Service Bulletin

PRELIMINARY INFORMATION

Subject: Shorter Front Bumper Fascia Air Deflector Available for Service

Models: 2011-2013 Chevrolet Volt

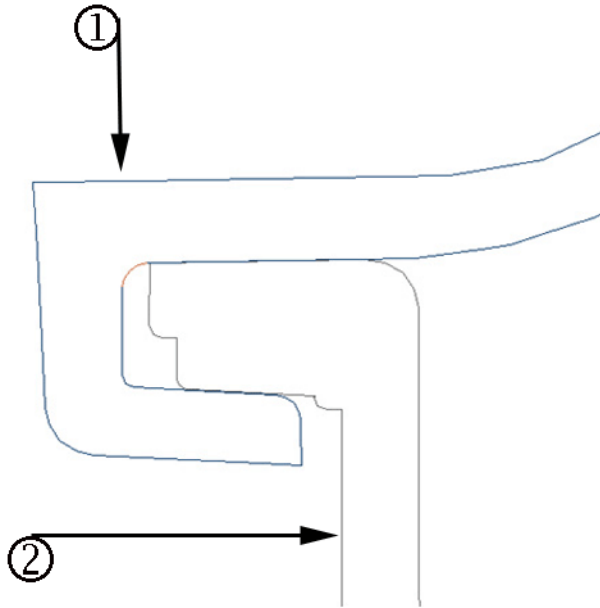
1. The two screws shown above are preinstalled at the plant and need to be removed from the wheelhouse liner prior to air deflector installation. Reinstall these screws first when installing the air deflector.

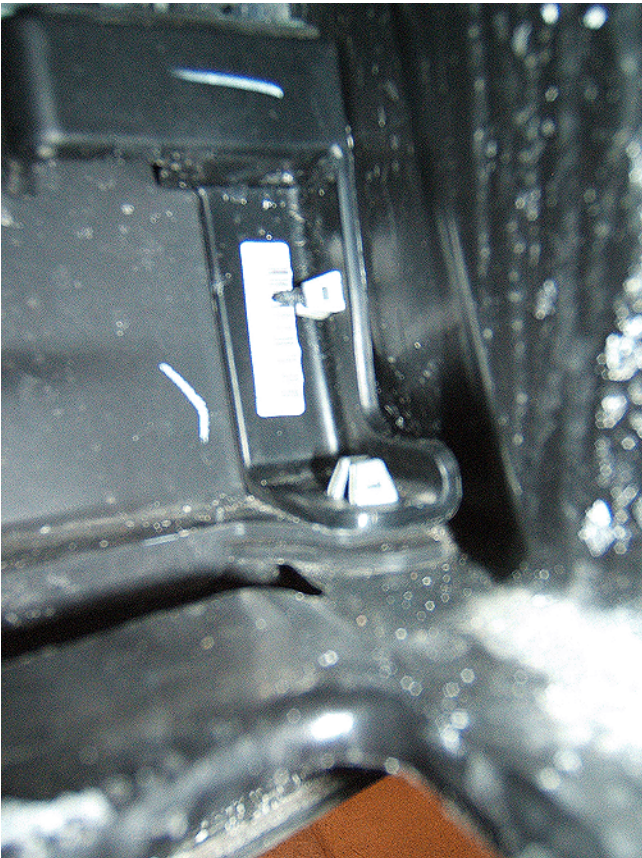
2. The air deflector (2) needs to be fully seated into the “C” channel on the lower fascia (1) as part of the assembly. Insertion into the “C” channel is a tight fit.
3. Prior to installing the screws, line up all three pieces of the air dam to the fascia first.

Important: When installing the screws, verify all holes line up and that the screw catches the retaining nut.

4. Working from the center section of the assembly helps eliminate any possible bowing when installing the remaining screws.

Important: The “C” channel must be fully inserted to ensure a quality fit.
